### APPEAL SUMMARY

<b>Appeal ID:</b> 14737	<b>Project Address:</b> 2014 NE Multnomah St
<b>Hearing Date:</b> 3/8/17	<b>Appellant Name:</b> Martha Williams, PE
<b>Case No.:</b> P-004	<b>Appellant Phone:</b> 5039466690
<b>Appeal Type:</b> Plumbing	<b>Plans Examiner/Inspector:</b> Chuck Luttmann
<b>Project Type:</b> lur	<b>Stories:</b> 8 <b>Occupancy:</b> R-2 <b>Construction Type:</b> 1-B
<b>Building/Business Name:</b> Sullivan's Gulch	<b>Fire Sprinklers:</b> Yes - Through Out
<b>Appeal Involves:</b> Erection of a new structure, Reconsideration of appeal	<b>LUR or Permit Application No.:</b> 15-215564-CO
<b>Plan Submitted Option:</b> pdf [File 1]	<b>Proposed use:</b> Mixed Use

### **Drywell System located beneath the building: Granted as proposed**

**Re:** Drywell Infiltration Design  
Sullivan's Gulch Apartments – Parcel 1  
SE 21st Avenue and SE Multnomah Street  
Portland, Oregon

1  
F200  
GROUND IMPROVEMENT PLAN  
1' = 10'-00"

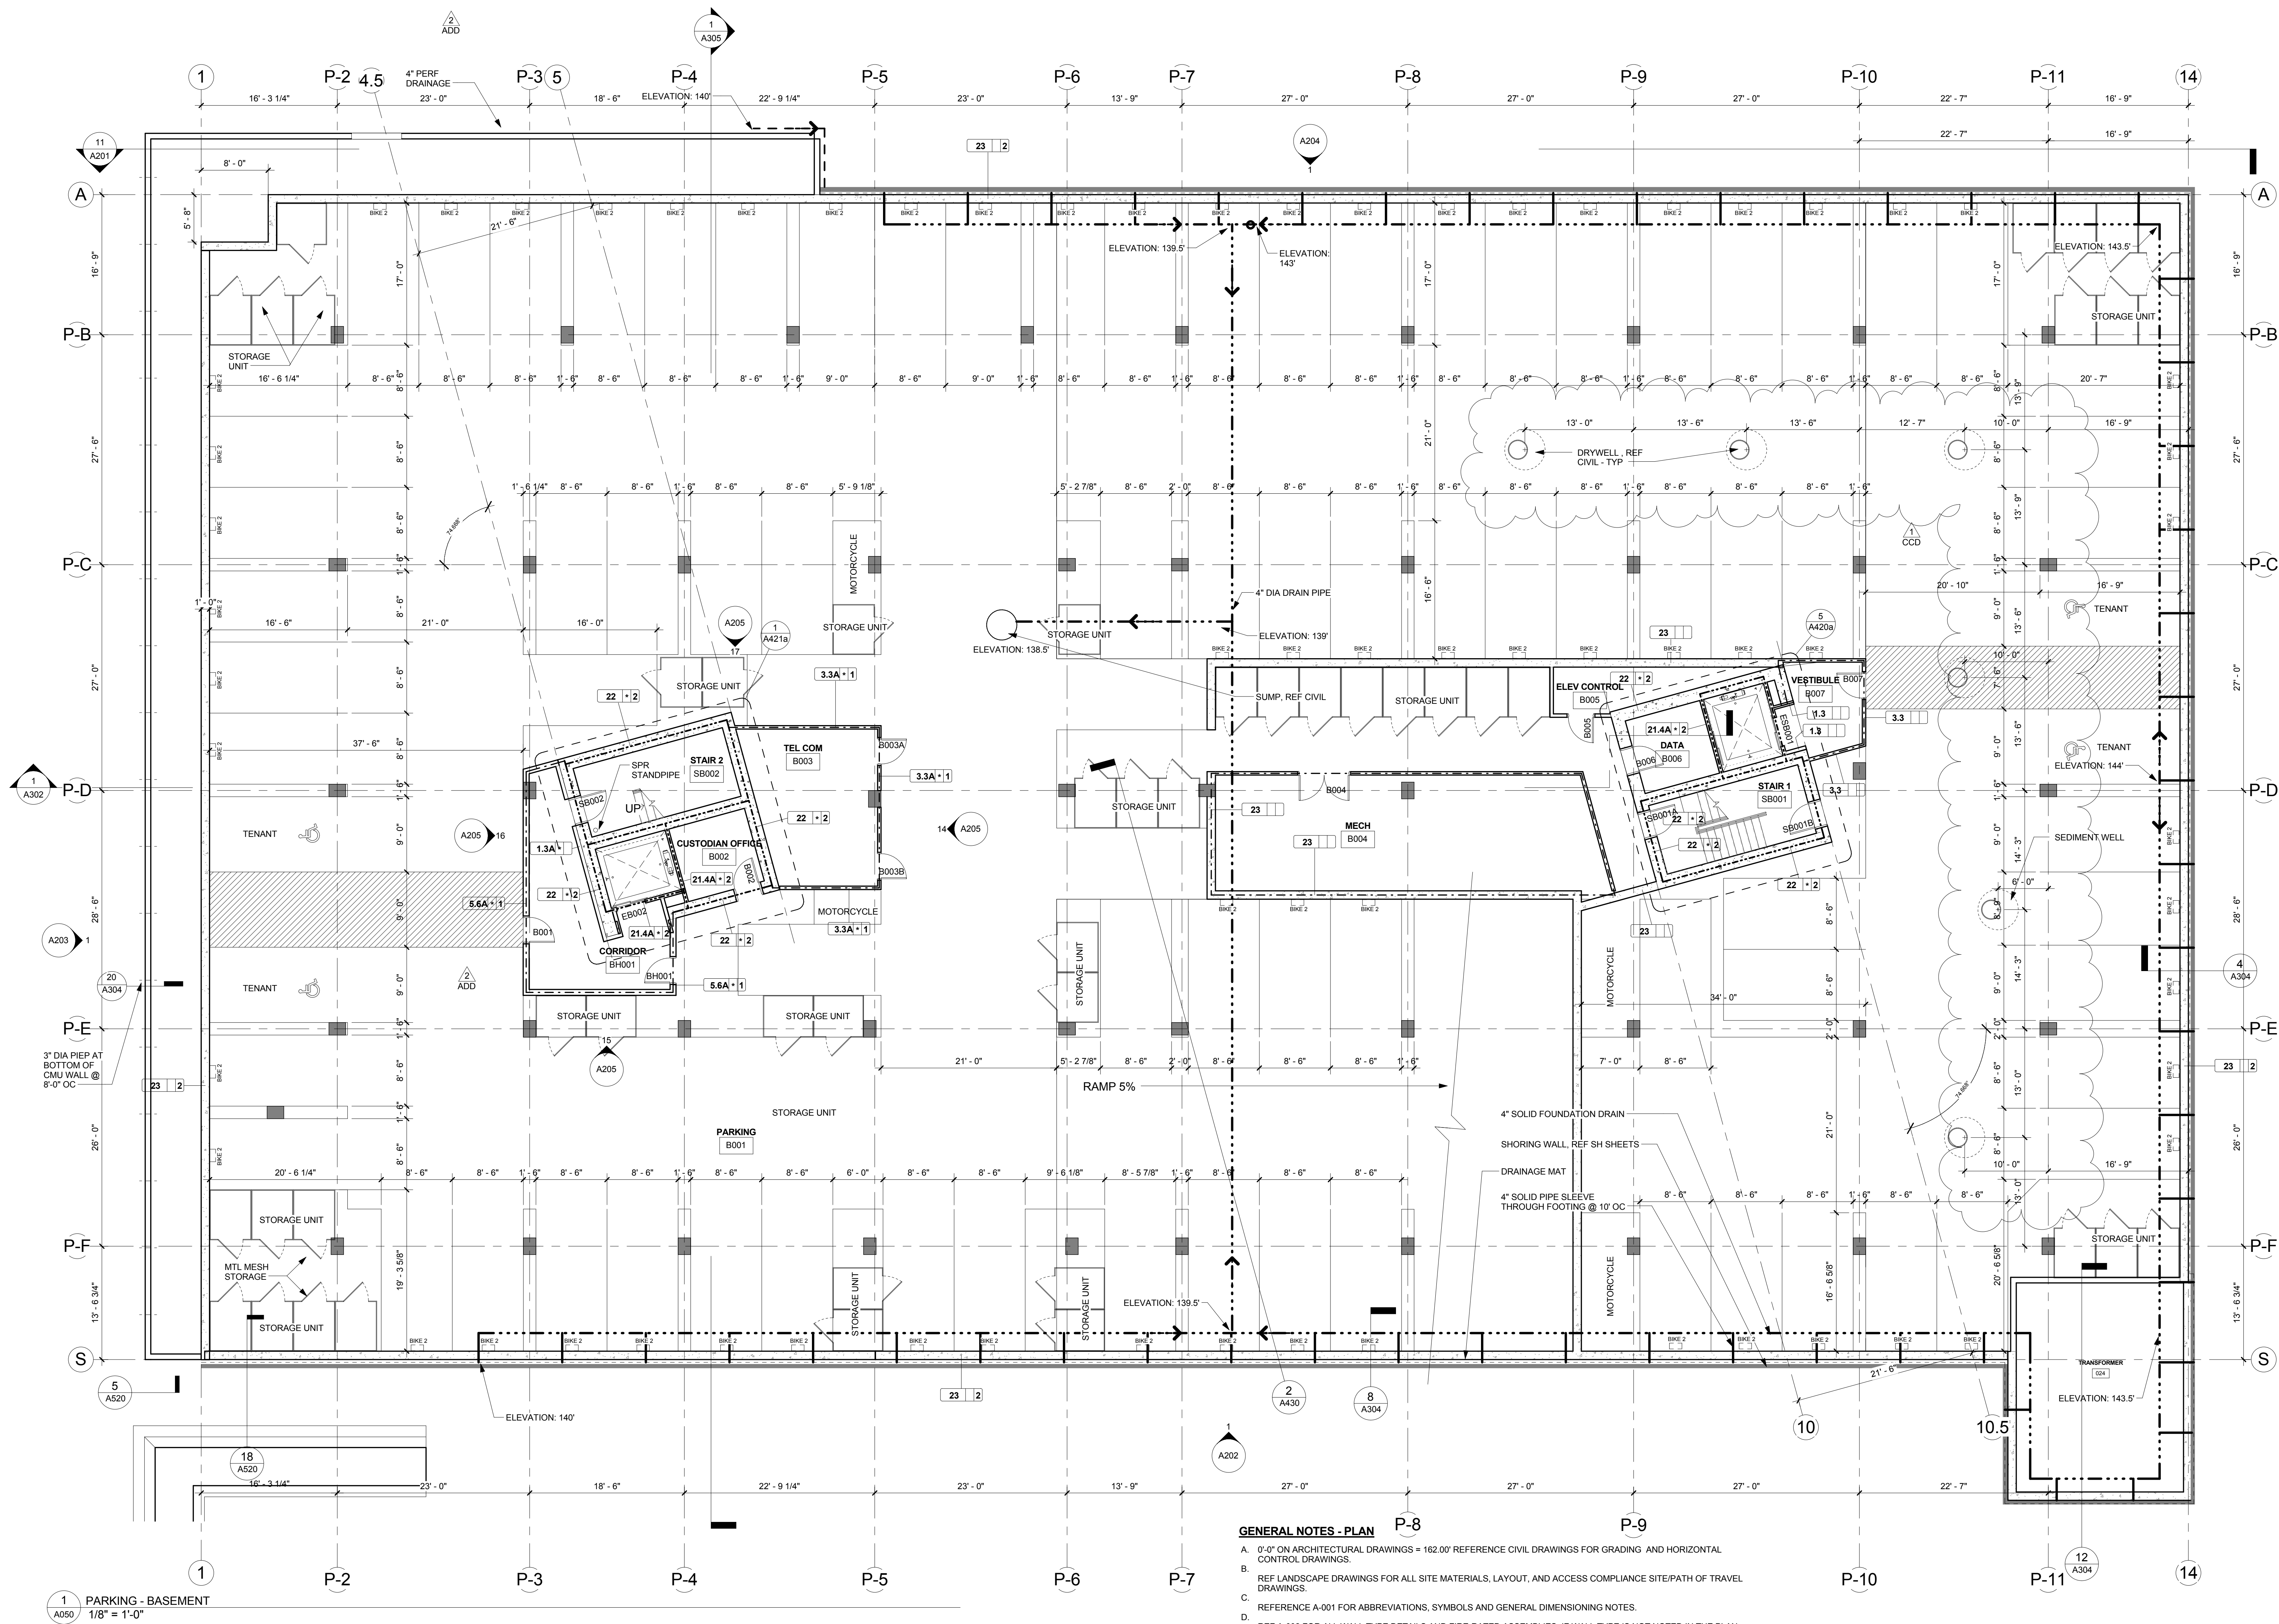
APPEAL ITEM 1

1. DRYWELL BEFORE RAP
2. 5' MIN FROM FOOTINGS
3. NORTH OF P.8
4. TIP EL. 120'-00" OR DEEPER (SEE 7 DEC 16 DRYWELL PLAN)

1. Tip elevation 120.00 feet or deeper
2. North of Gridline P-8.
3. More than 5 feet from all foundation perimeters.
4. Installed before installing rammed aggregate piers.

We concur with GRI's design recommendations and conclude that the planned drywell installation will not have adverse effect on the rammed aggregate pier design.
